Technical Bulletin (TB-0028A) 3-Lead Terminal Plates

Version 1, January 2014

Fig. 1

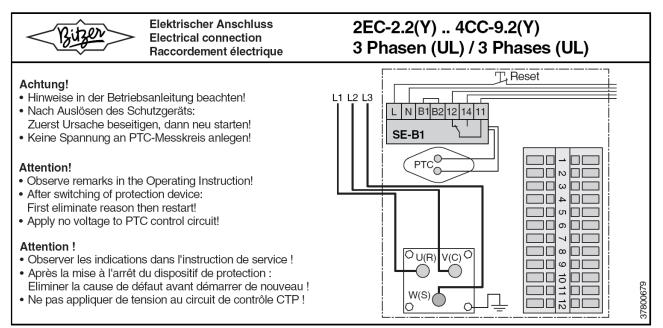
The terminal plate for the Ecoline CE3 series compressors has been update. Below are instructions on the proper procedure for wiring the compressor. The label on the terminal box of CE3 motors is also shown below.

- 1. Place brass washer on each post
- 2. Place wire terminal on each post (not shown, field supplied)
- 3. Place another brass washer on each post
- 4. Screw an M5 brass nut on to each post and torque to 2 ft lbs (3 Nm)
